ADDENDUM NO. 1

DATE: 04/30/26

PROJECT: Opstad Elementary School Parking Lot Expansion
Snoqualmie Valley School District

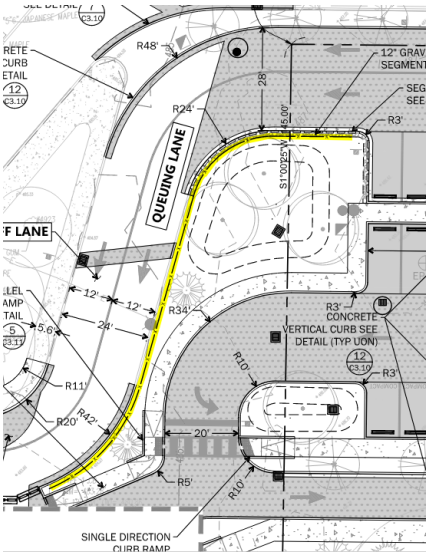
PRE-BID QUESTION NO. 7
Are alternative fixtures for on-site poles allowed?

Response:
The intent of the Cree Guideway fixtures is to match the look and feel of the existing on-site light poles to remain. Alternative fixtures may be considered with engineer approval. A fixture adapter may be required for connection to both the new and existing on-site poles.

Sheet
C3.11

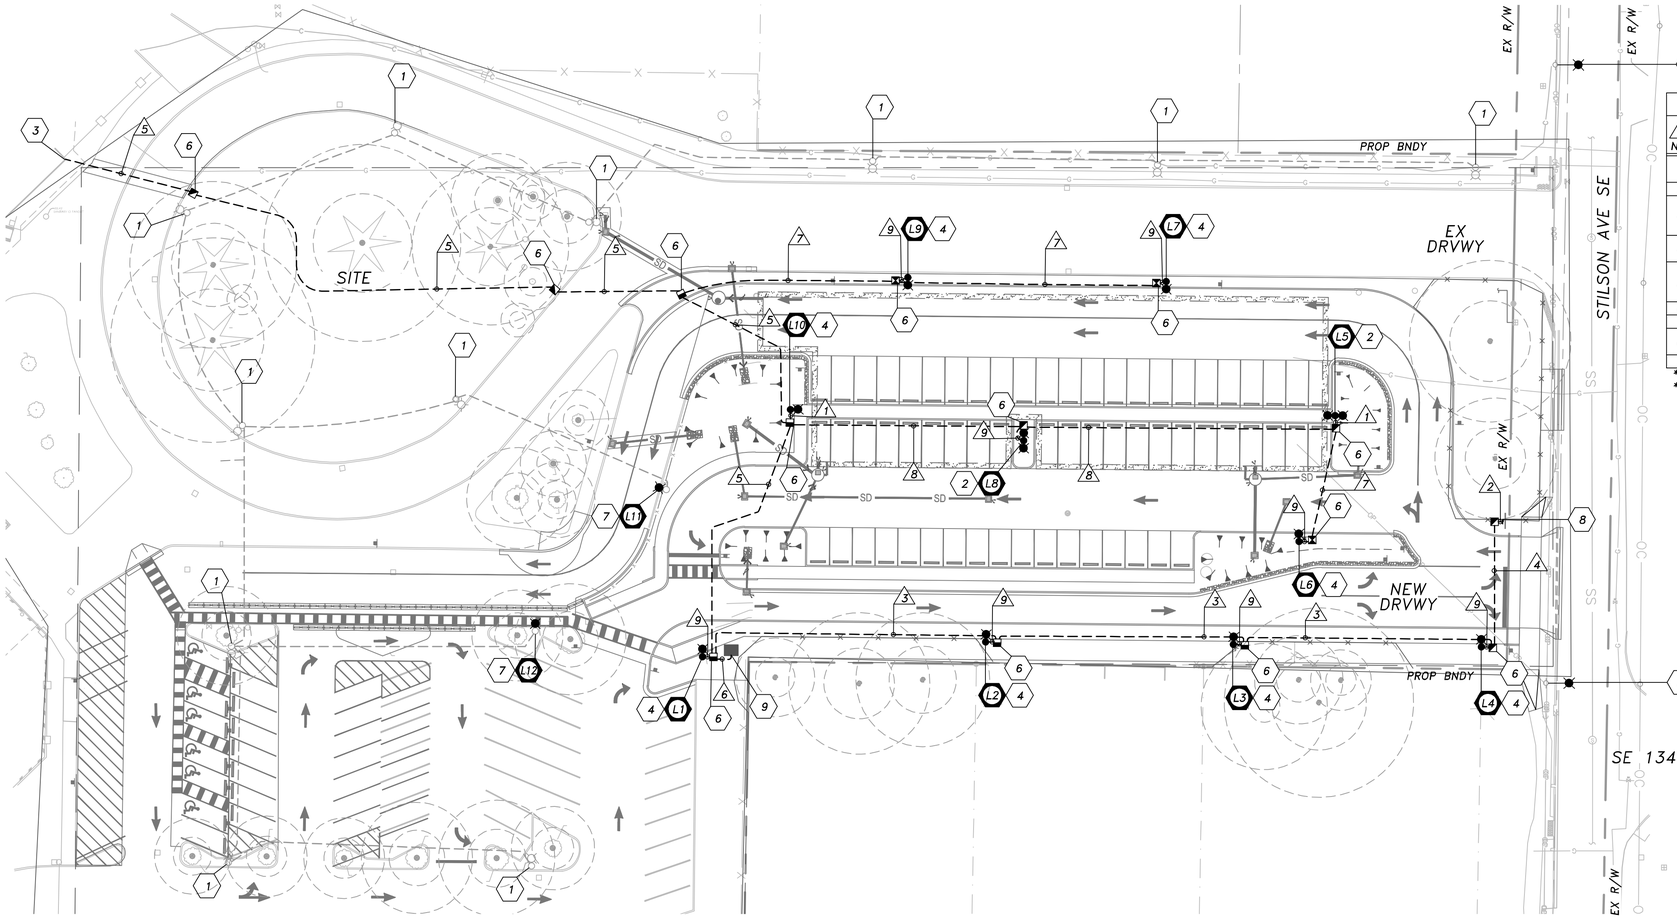
PRE-BID QUESTION NO. 1
Sheet C3.11 detail 3 shows the grind and overlay and notes that petro mat or approved equal is required. Paving fabrics do not adhere to a surface that has been ground. Here are 2 options to consider:

1) Eliminate the petro mat completely
2) Grind the existing a minimum of 3 inches and prelevel prior to installing the petro mat. This will provide a smooth and surface for the petro mat to adhere to. The concern with this method is that the existing asphalt might not be thick enough to allow this procedure.

I would recommend deleting the petro mat but please let me know which way the owner want to proceed.

Item #C01 SHEET C3.11 – PAVING DETAILS
ADD #01 A. **Revise** Detail 3 to delete petromat information and replace with tack coat as noted on revised detail 3 on Sheet C3.11 attached.

Response:
The intent of the petro mat in Detail 3 on C3.11 was to provide a moisture barrier and help reduce reflective cracking in the new overlay. Given that:

- The existing asphalt thickness is unknown and may not allow a 3-inch grind and prelevel
- Paving fabrics generally do not adhere well directly to a milled surface as you noted

Therefore, we agree that the current detail is not practical as shown.
See revised detail 3 on C3.11.

1. PLACE ASPHALT CONCRETE PAVEMENT IN ACCORDANCE WITH WSDOT APWA SECTION 5-04.
2. ASPHALT PAVEMENT OVERLAY SHALL BE PLACED IN (1) LIFT. FINAL LIFT SHALL BE CONSTRUCTED WITH THE OVERLAY OF THE EXISTING ASPHALT ONLY AFTER PAVEMENT PATCHING IS COMPLETE.
3. CLEAN EX MILLED ASPHALT SURFACE (SWEEP & VACUUM), PRELEVEL MILLED SURFACE AS NEEDED, THEN APPLY TACK COAT - USE CSS-1 OR EQUAL.

Sheet
OS-01

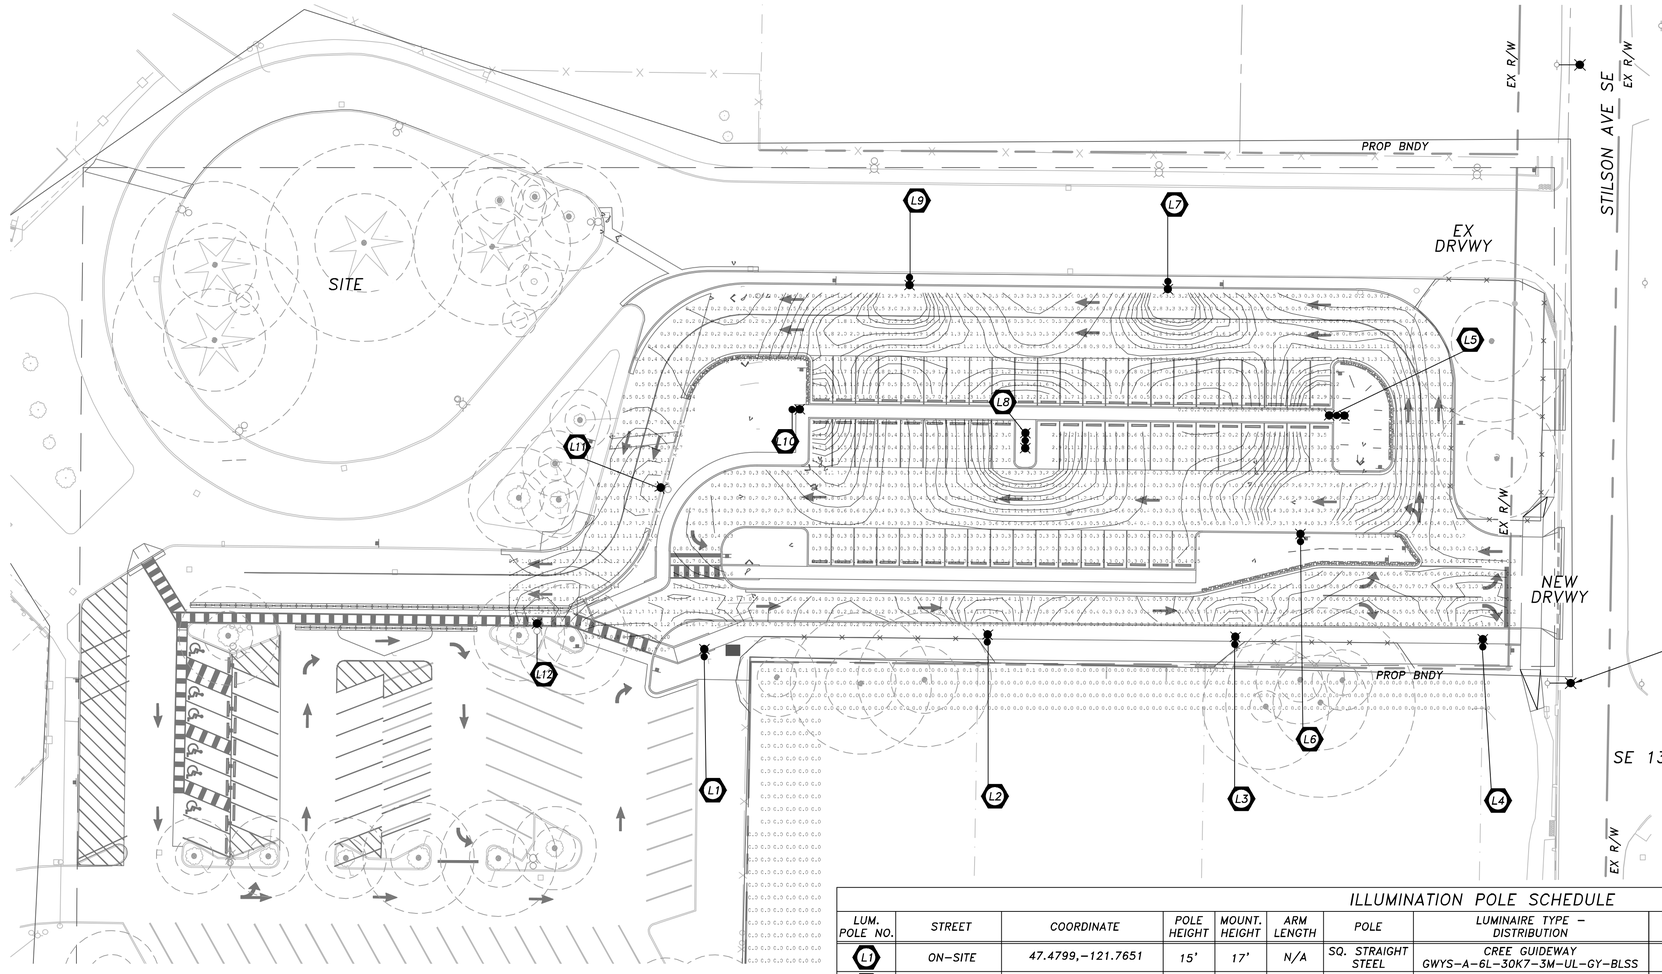
PRE-BID QUESTION NO. 6
Clarification on junction box types?

Item #IL01 SHEET OS-01 – ON-SITE ILLUMINATION PLAN
ADD #01 A. **Revise** junction box description in legend.
B. **Revise** allowance for alternative light fixture with engineer approval.

Response:
Junction box type labels have been added to the legend in the revised on-site illumination plan.

* OR APPROVED EQUIVALENT FIXTURE. ALL FIXTURES SHALL BE REVIEWED AND APPROVED BY THE ENGINEER PRIOR TO PROCUREMENT
